ADDENDUM NO. 2
CONTRACT NO. CP8126-1 – GENERAL, MECHANICAL AND
ELECTRICAL CONSTRUCTION
 DATED: SEPTEMBER 27, 2010

SUFFOLK COUNTY DEPARTMENT OF PUBLIC WORKS
DIVISION OF SANITATION
HAUPPAUGE INDUSTRIAL PARK
S.C.S.D. NO. 18 – INDUSTRIAL SEWER DISTRICT EXPANSION
SUFF 0503

SUFF 0503
ADDENDUM #2 - ITEM B
SHEET HP1 - SKETCH # 1

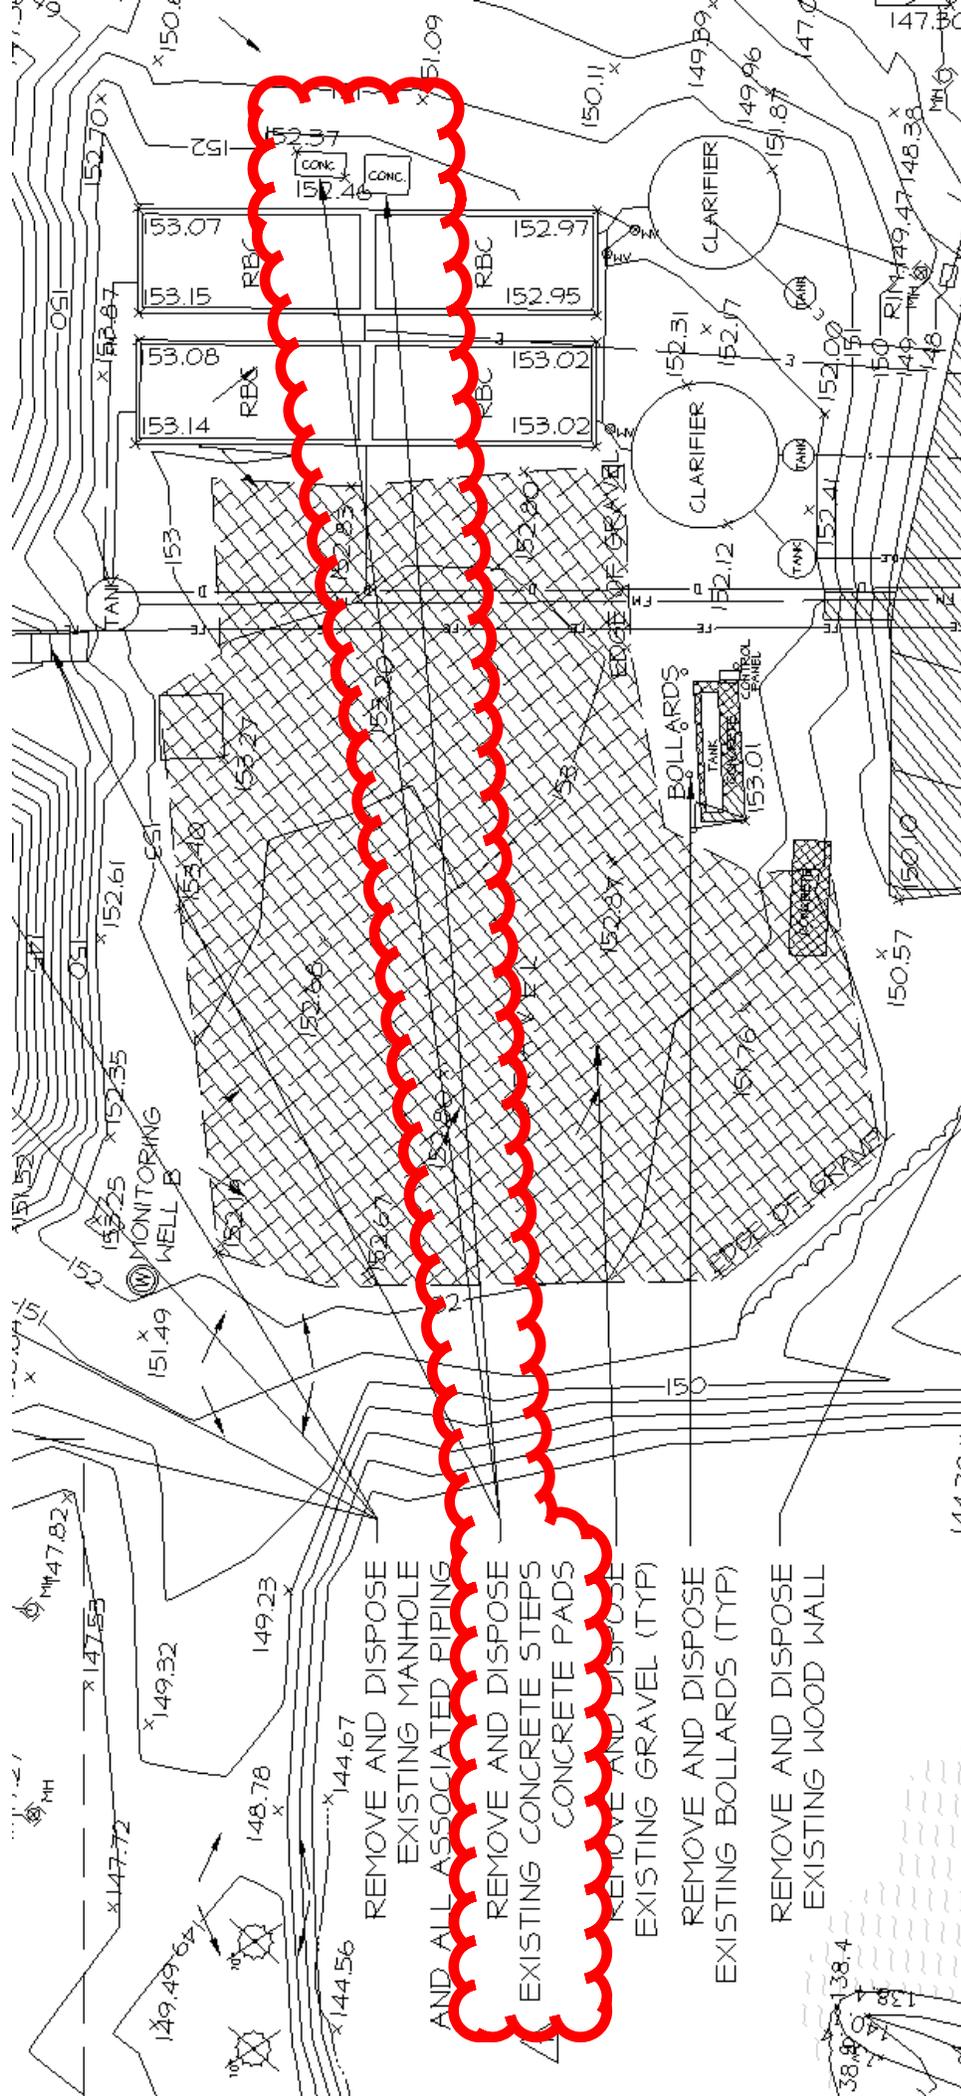
1. Modify Mass Balance Diagram to change disk filter effluent BOD value from “105 lbs/day (5 mg/L)” to “210 lbs/day (10 mg/L)”. (see sketch #1 included herein)

SUFF 0503
ADDENDUM #2 - ITEM F
SHEET C5 - SKETCH # 3

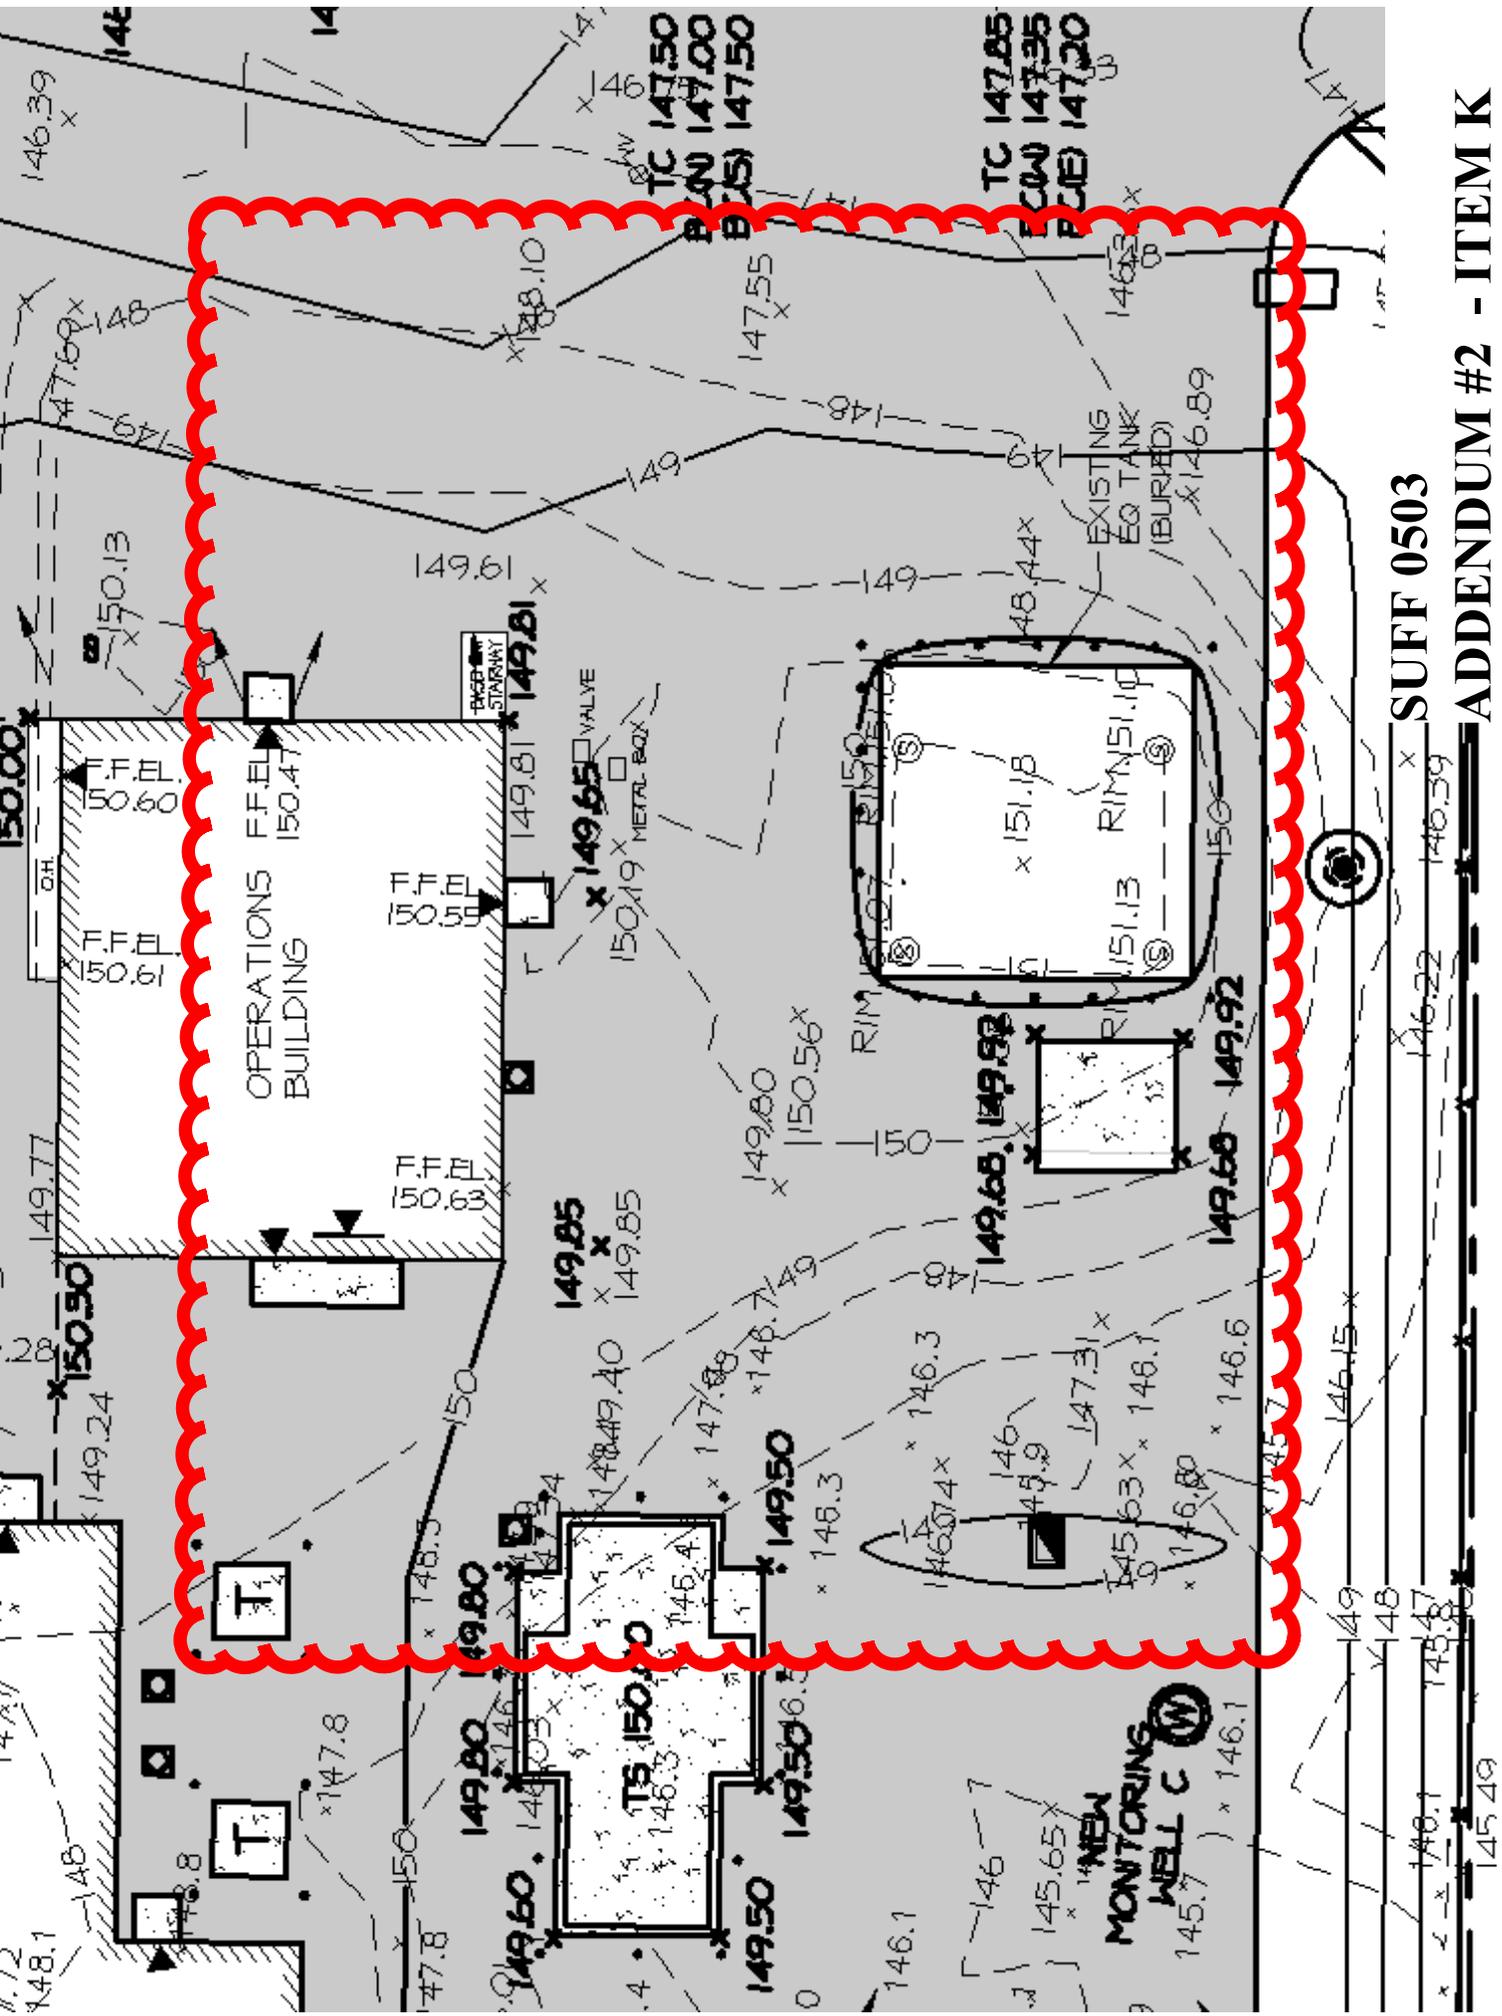
- F. SHEET C5:
1. Add second RBC blower pad to be demolished to site demolition plan. (see sketch #3 included herein)
- G. SHEET C6:
1. Modify to show routing of plant/recycled water from Operations Building to Headworks Building.

SHEET C10 - SKETCH # 4

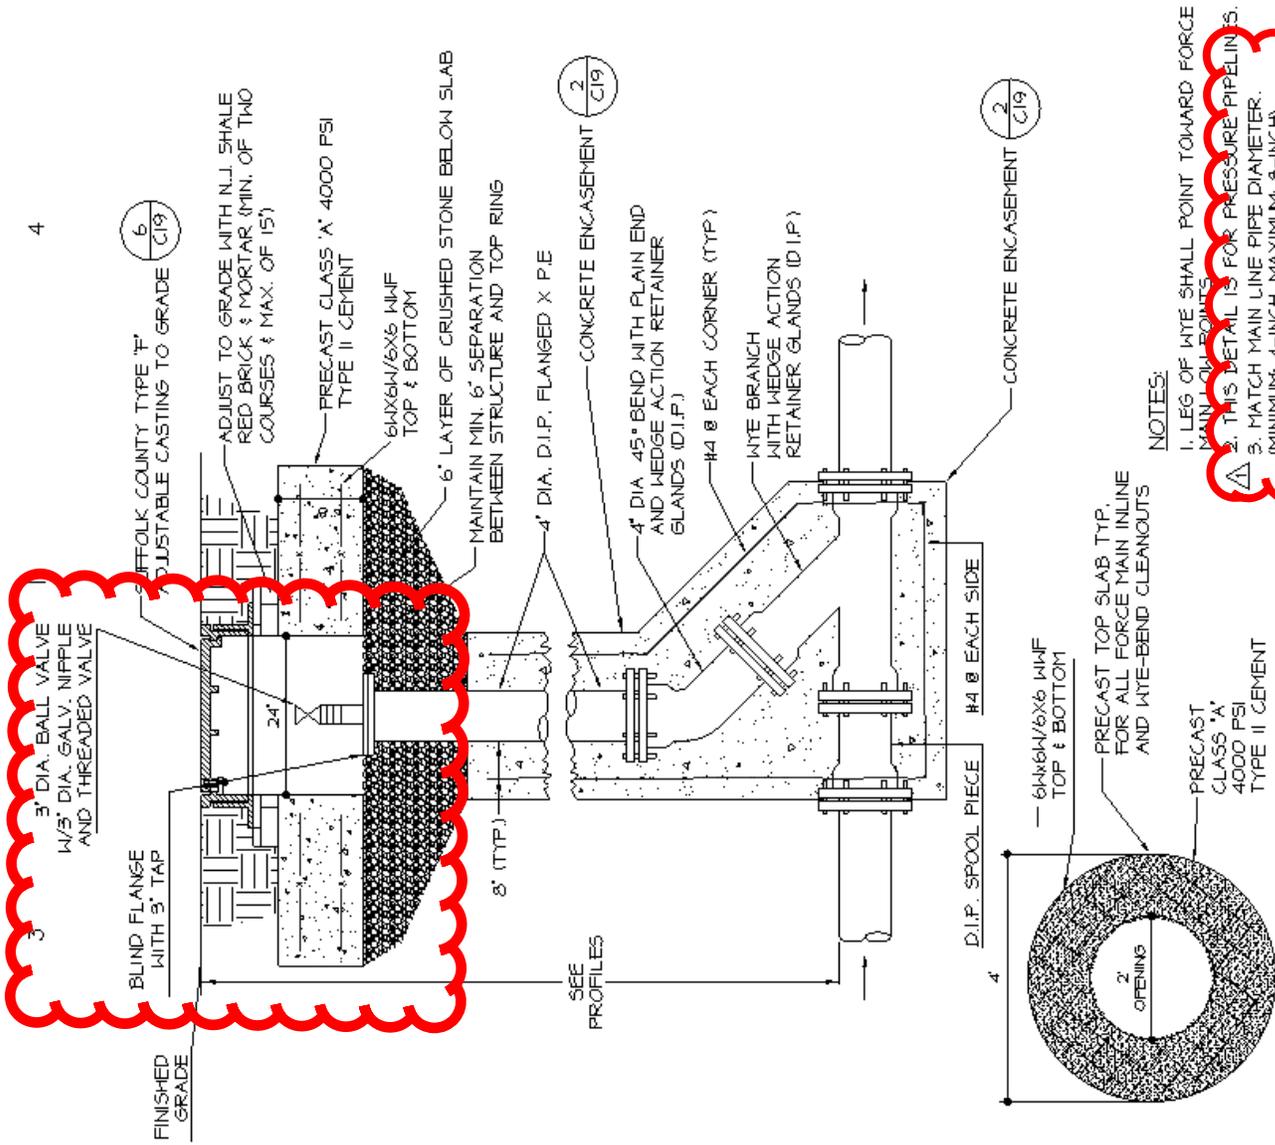
1. Modify contour lines and spot grades to reflect change to T.O.T. elevation of proposed thickened sludge holding tank from 151.00' to 150.00'. (see sketch #4 included herein)

**ADDENDUM #2 - ITEM O
SHEET C20 - SKETCH # 5**

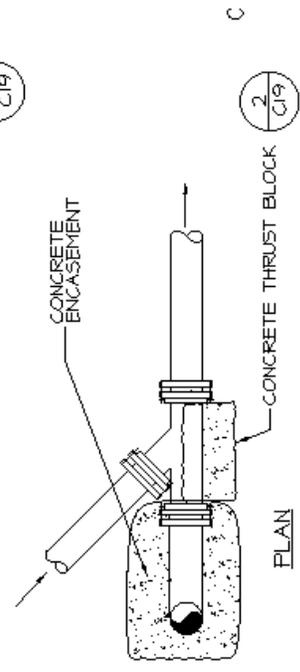
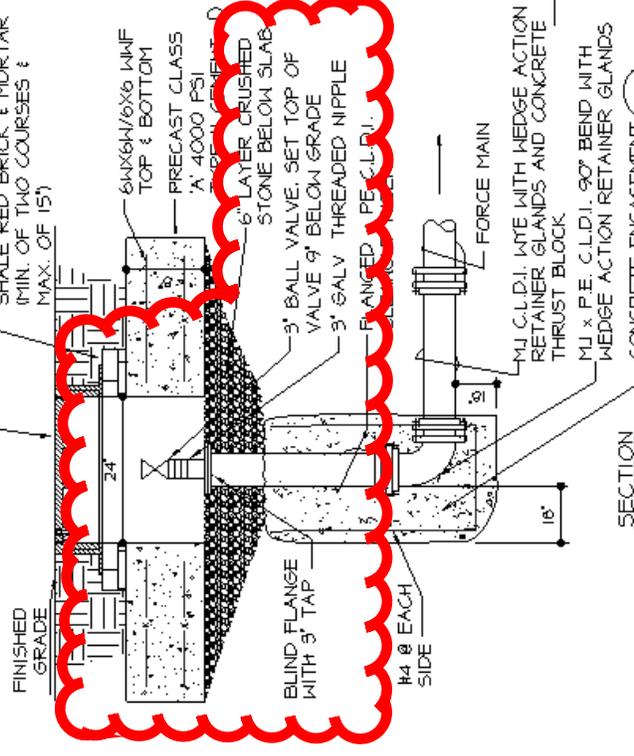
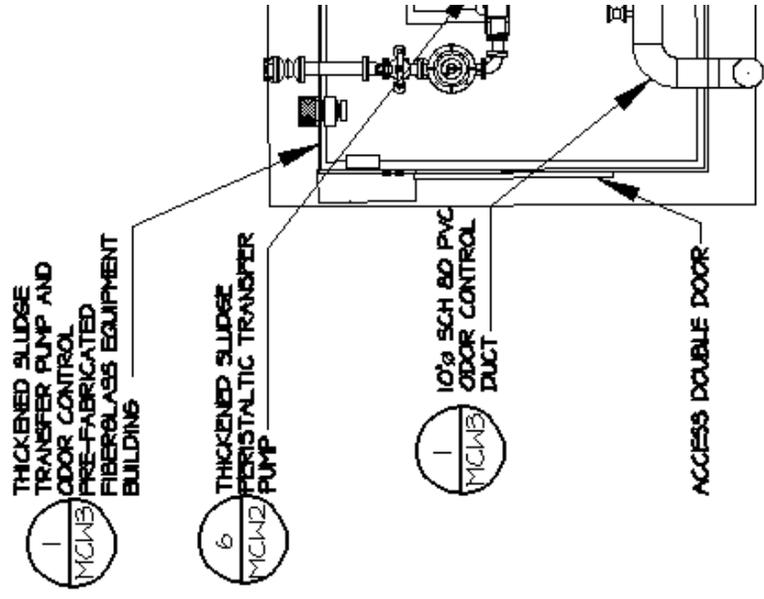
1. Modify details 2 and 3: Raise blind flange on both details and increase pipe size at or above flange from 2-inch to 3-inch.
2. Add the following note to details 2, 3 and 7: “Match main line pipe diameter. (minimum: 4-inch, maximum: 8-inch)”.
3. Above revisions as shown in sketch #5 included herein.

ADDENDUM #2 - ITEM P
SHEET MCW1 - SKETCH # 6

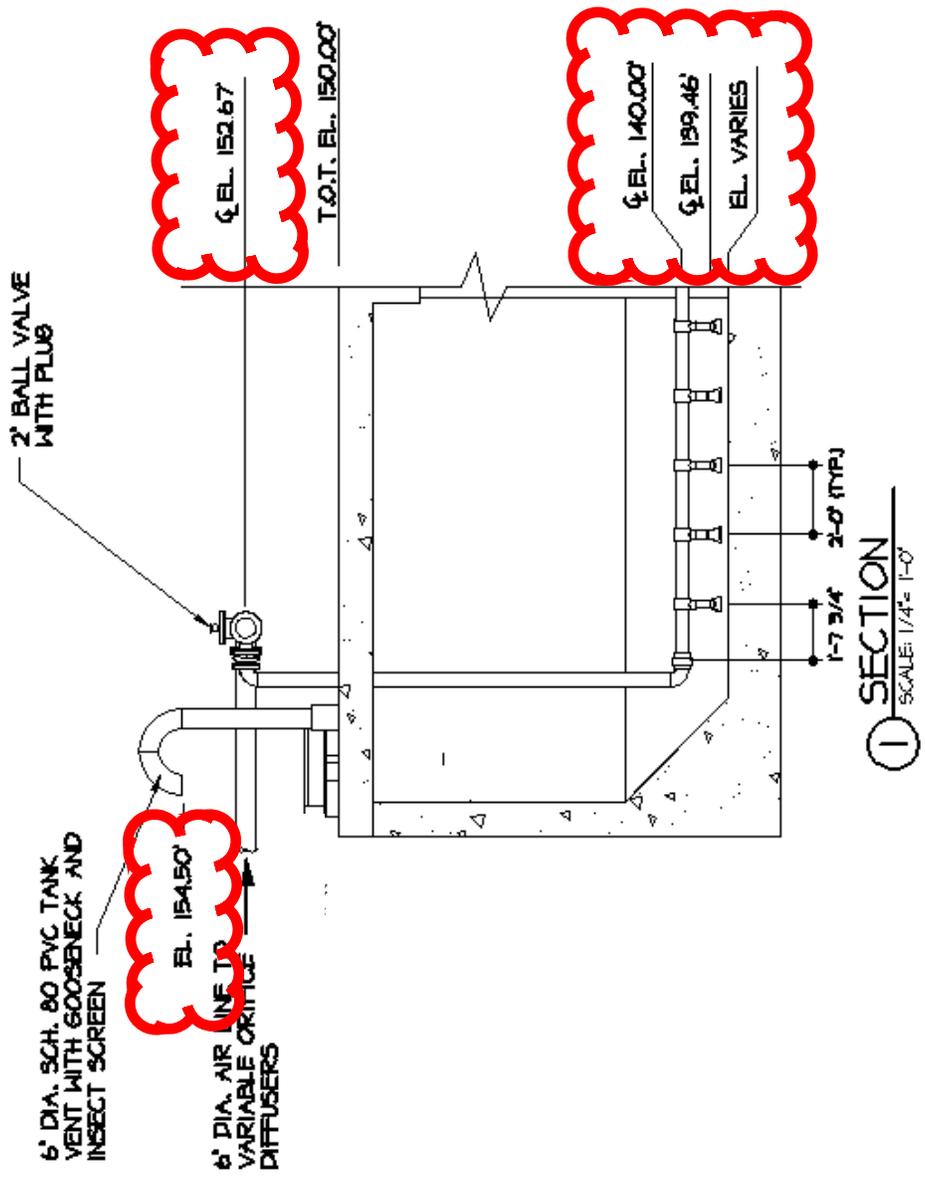
1. Detail #2:
 - a. Add callout to top of proposed thickened sludge holding tank that reads: “Remove approximately 12” thick layer of topsoil from holding tank to expose top slab”.
 - b. Add callout to manhole castings of proposed thickened sludge holding tank that reads: “Remove and replace existing manhole castings with heavy duty 30” slab top gasketed castings, Pacific Marine & Industrial Model R-1581 or equal. Anchor casting to top slab with stainless steel anchors. Turn over existing castings to Owner”.
2. Above revisions as shown in sketch #6 included herein.
